CARRIER, MAINTENANCE, FULL TRACKED, MKs 1 AND 1/1 FV434

GENERAL INSTRUCTION NO. 1

SUBJECT: EMER TV E 109/4 Miscellaneous Instructions No. 1 to No. 8

Fig 2 Replacement of the front access cover hinges (hull), set from the hatch hinges

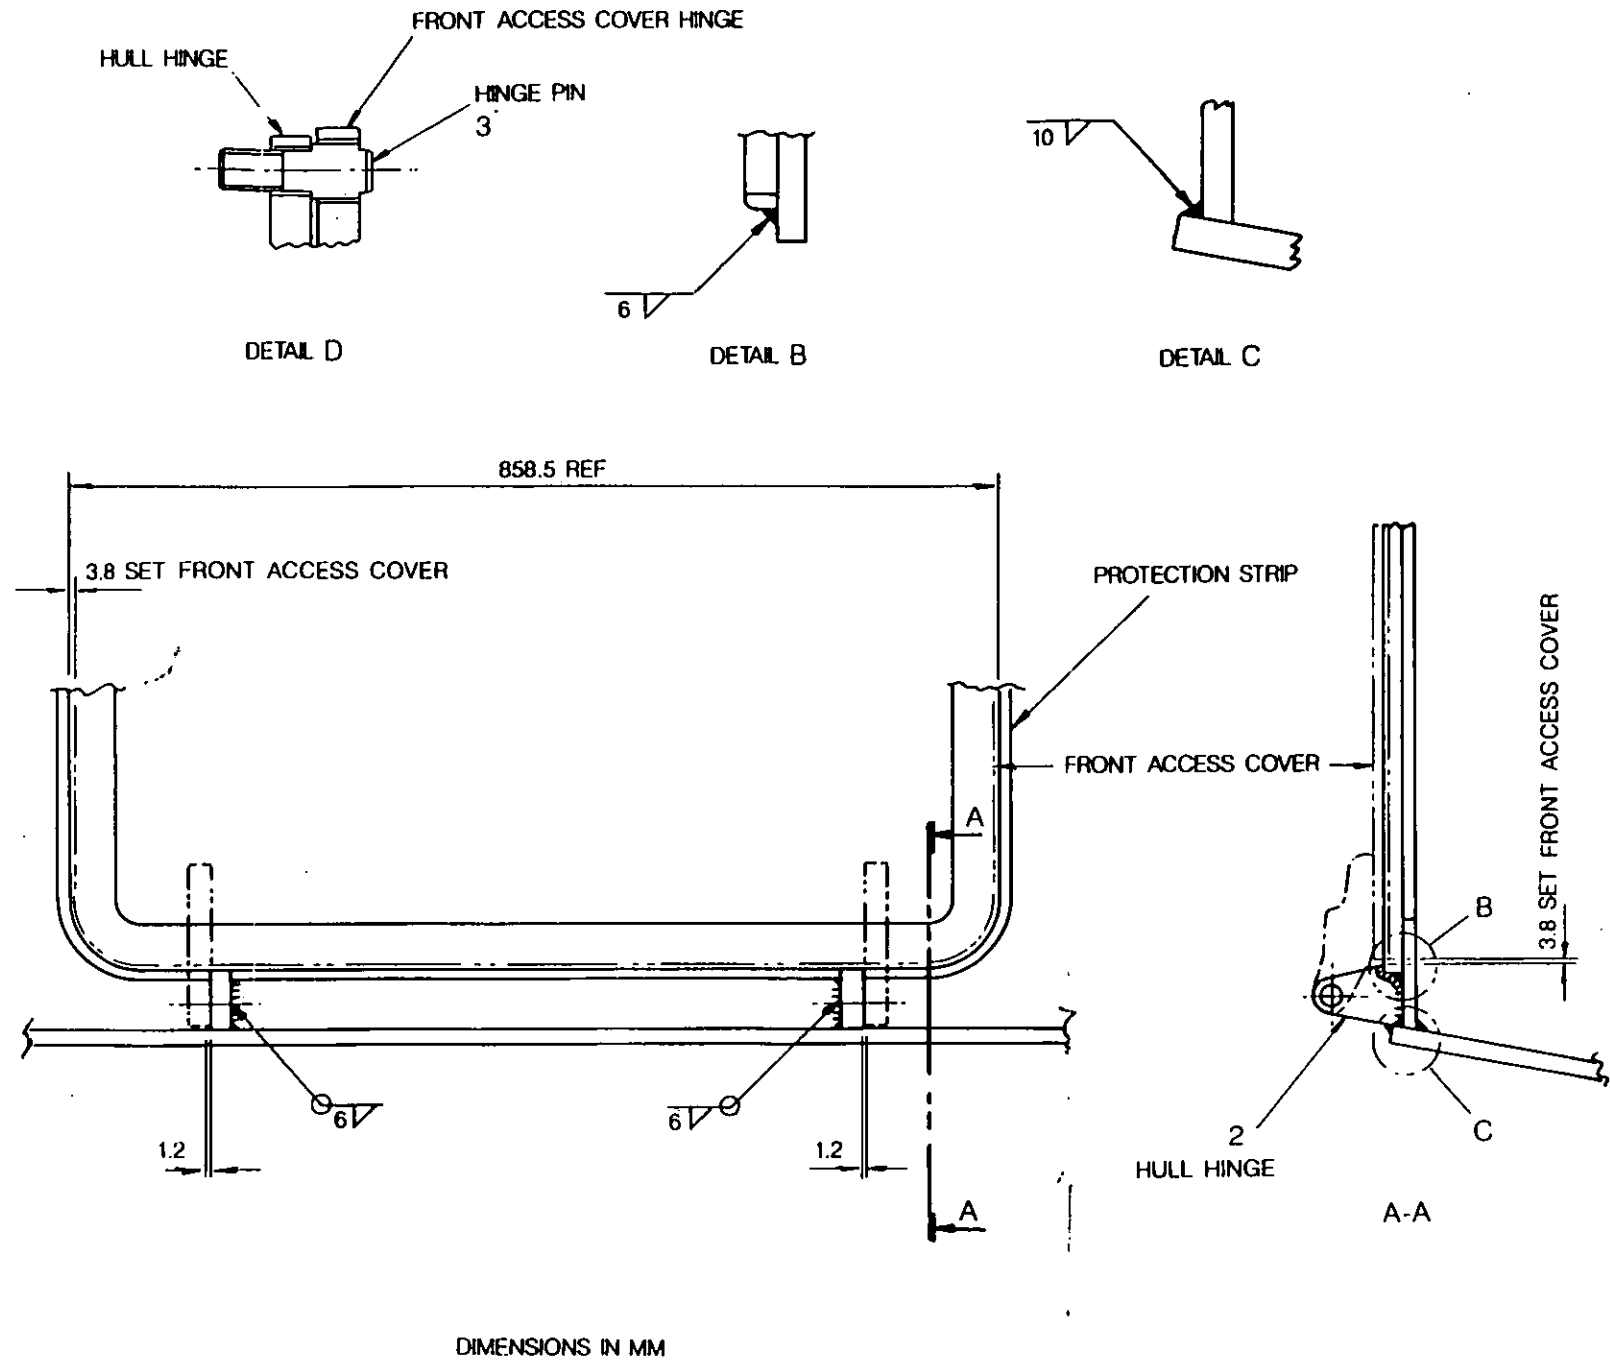
9.2 To replace the front access cover hinges (hull), follow the repair scheme detailed at Fig 2.

- (1) This scheme is to be used when only the hinges on the hull are to be replaced. Hull hinge positions are set from existing front access cover assembly hinges.
- (2) Welding is to be carried out to EMER Wksp O 360 Chap 12, using a 3.25 mm rod.
- (3) Before commencing with repair, remove front access cover from the vehicle.

- 1 Remove existing hull hinges by gas cutting or gouging to within 6 mm of armour plate. Avoid damaging protection strip.
- 2 Remove remaining metal by grinding. Avoid overheating of armour plate.
- 3 Finish smooth armour plate and protection strip and use NDT (penetrant dye) to establish that no surface cracks are present.

- 4 Replace weld removed from edge of protection strip during ops 1, 2 and 3 with a fillet weld as indicated on detail 'B'.
- 5 Locate front access cover on vehicle, set to 3.8 mm and clamp in position.

- 6 Set first hull hinge to 1.2 mm from first front access cover hinge and align holes centres using hinge pin (item 3). Make initial root weld along bottom edge of hinge and hull.

- 7 Set second hull hinge to 1.2 mm from second front access cover hinge and align holes using hinge pin (item 3). Make initial root weld along bottom edge of hinge and hull.

- 8 Check accuracy of hinge for position and squareness and use hinge pin (item 3) to ensure clearance when pivoting. See detail 'D'.
- 9 Unclamp front access cover and remove from vehicle.

- 10 Complete fillet welding of hull hinges as shown.
- 11 Replace weld removed from hull nose plates during ops 1, 2 and 3 with a fillet weld as indicated as detail 'C'.

- 12 Inspect.
- 13 After 72 hours, check that welds and plates are crack free.
- 14 Finish to Def Stan 03-32 Part 2, colour as per contract.

Fig 3 Replacement of the front access cover hinges (hull), set to the original build standard

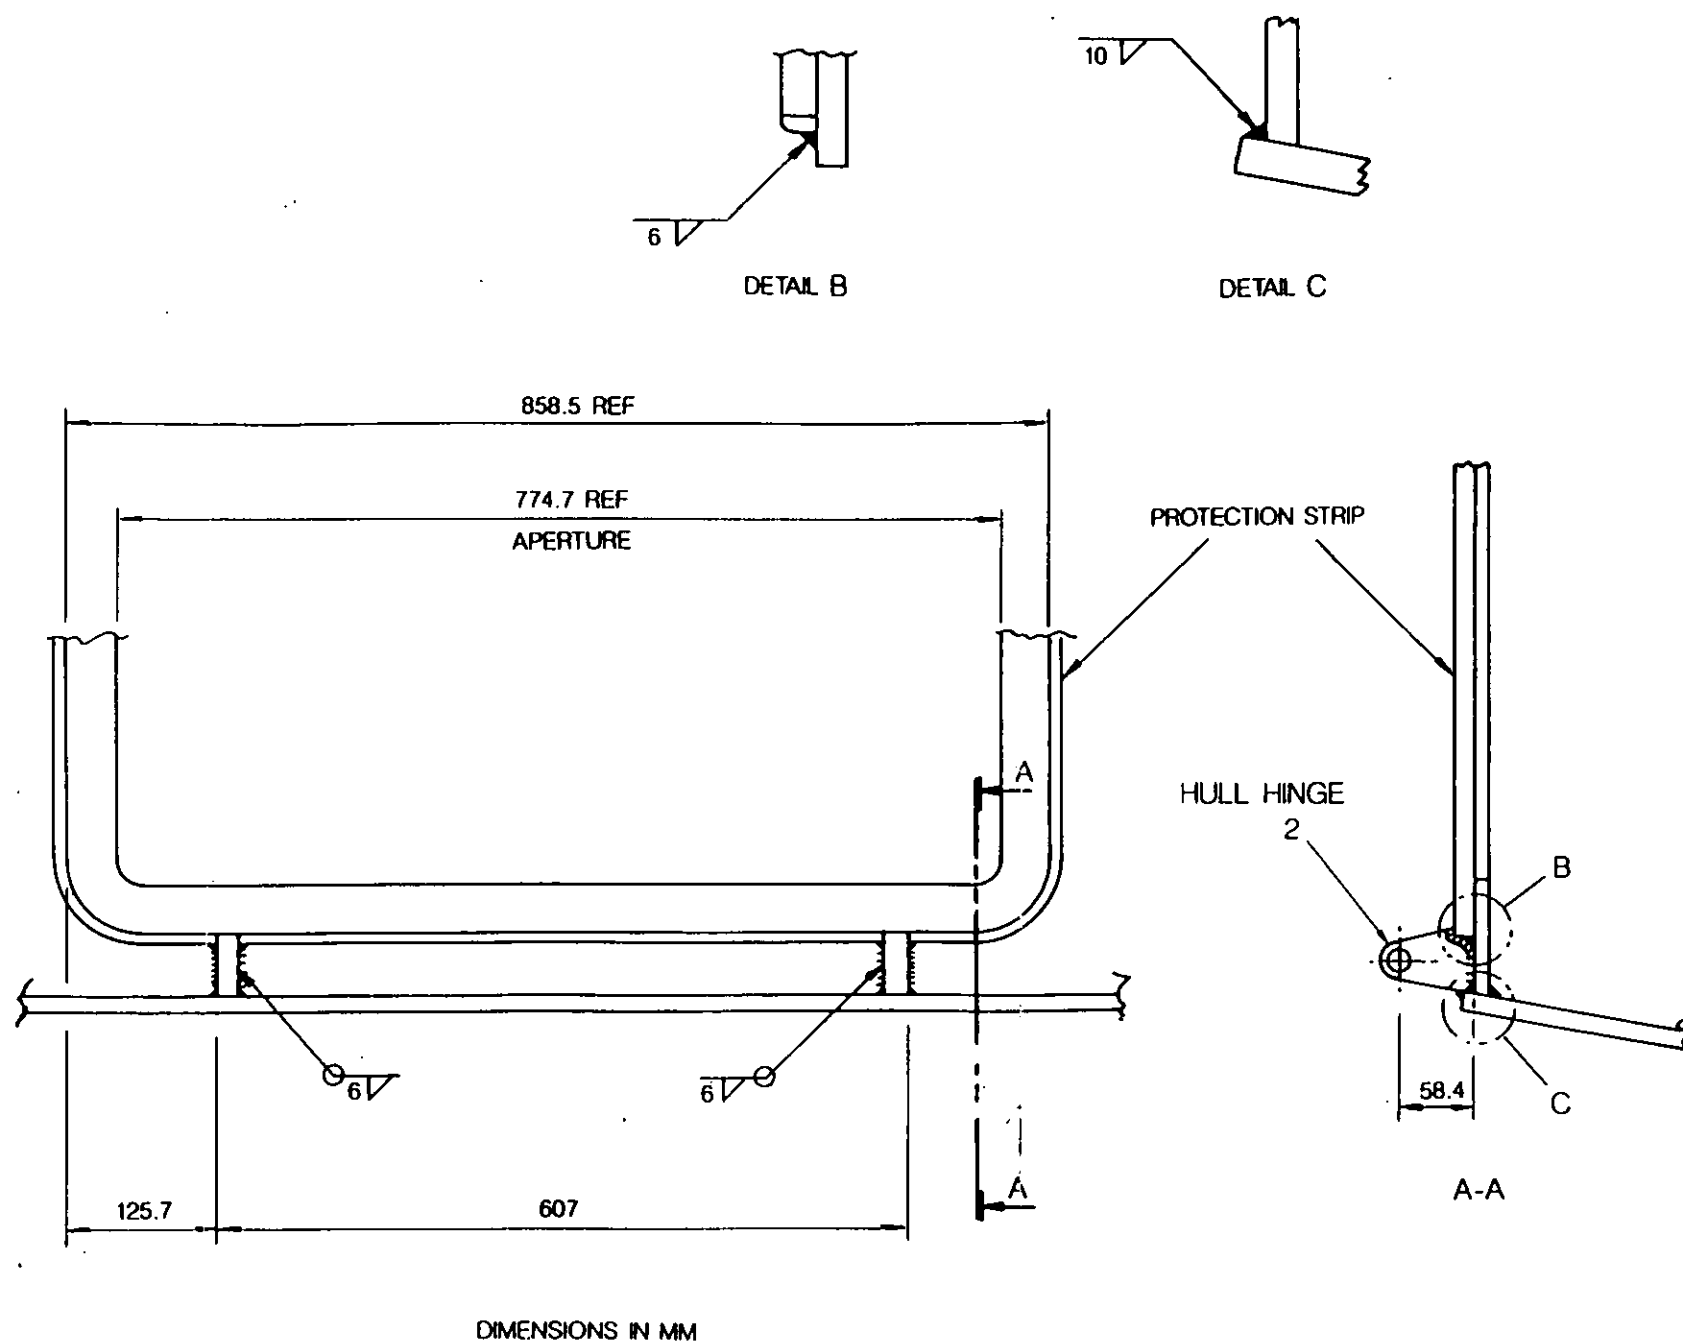
9.3 To replace the front access cover hinges (hull and hatch), follow the repair scheme detailed at Fig 3, followed by the repair scheme detailed at Fig 1.

- (1) This scheme is to be used when the hinges on hull and front access cover are to be replaced. Use this scheme to replace the hull hinges, followed by the scheme detailed at Fig 1, to replace the front access cover hinges.
- (2) Welding is to be carried out to EMER Wksp O 360 Chap 12, using a 3.25 mm rod.
- (3) Before commencing with repair, remove front access cover from the vehicle.

- 1 Remove existing hull hinges by gas cutting or gouging to within 6 mm of armour plate. Avoid damaging protection strip.
- 2 Remove remaining metal by grinding. Avoid overheating of armour plate.
- 3 Finish smooth armour plate and protection strip and use NDT (penetrant dye) to establish that no surface cracks are present.

- 4 Replace weld removed from edge of protection strip during ops 1, 2 and 3 with a fillet weld as indicated at detail 'B'.
- 5 Set first hinge to 125.7 mm from inside of protection strip and make initial root weld along bottom edge of hinge.
- 6 Check accuracy of hinge for position and squareness .
- 7 Complete fillet welding of hinge as shown.
- 8 Set second hinge to 607 mm and make initial root weld along bottom edge of hinge.
- 9 Check accuracy of hinge for position and squareness .
- 10 Complete fillet welding of hinge as shown.
- 11 Replace weld removed from hull nose plates during ops 1, 2 and 3 with a fillet weld as indicated at detail 'C'.
- 12 Inspect.
- 13 After 72 hours, check with NDT that welds and plates are crack free.
- 14 Finish to Def Stan 03-32 Part 2, colour as per contract.

Fig 1 Lockout damper bracket LH

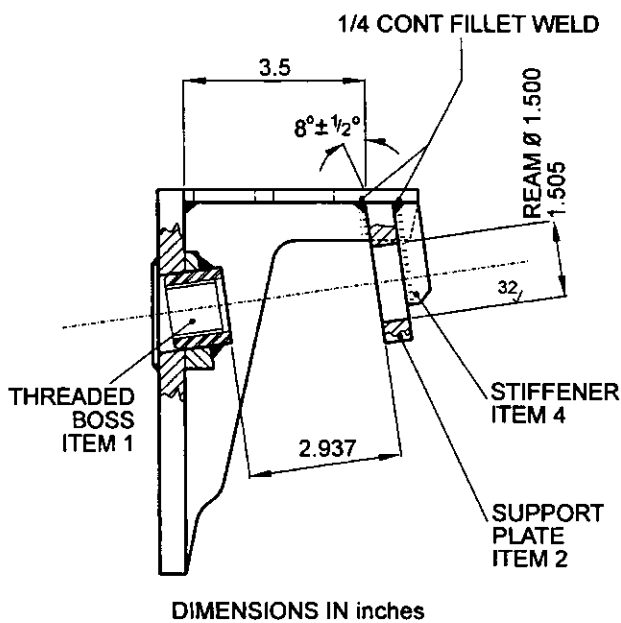
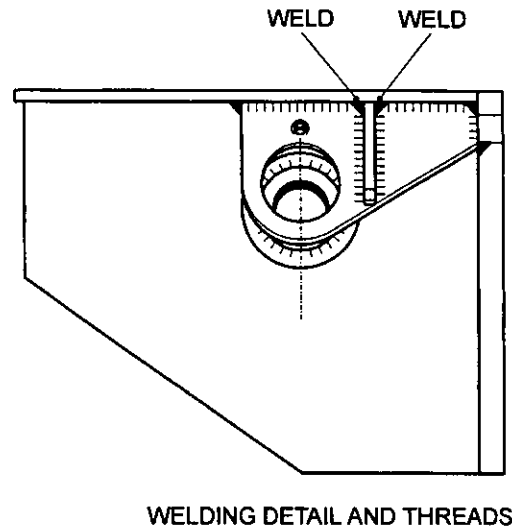
9.1 Inspect the threaded boss (item 1) for wear and damage, remove threaded boss and clean surrounding area by grinding or plasma cutting if required.

9.4 Inspect the support plate (item 2) and measure the hole diameter for damper mounting pin (item 5).

9.5 For diameters in excess of 1.505 in., but not exceeding 1.545 in., the hole can be weld repaired.

9.6 Weld fill the worn area of the support plate (item 2), and machine to size.

9.8 For diameters in excess of 1.545 in., the support plate (item 2) and stiffener (item 4) are to be replaced.

9.11 Modify support plate (item 2) I.A.W drawing ABRO BOV 1622.
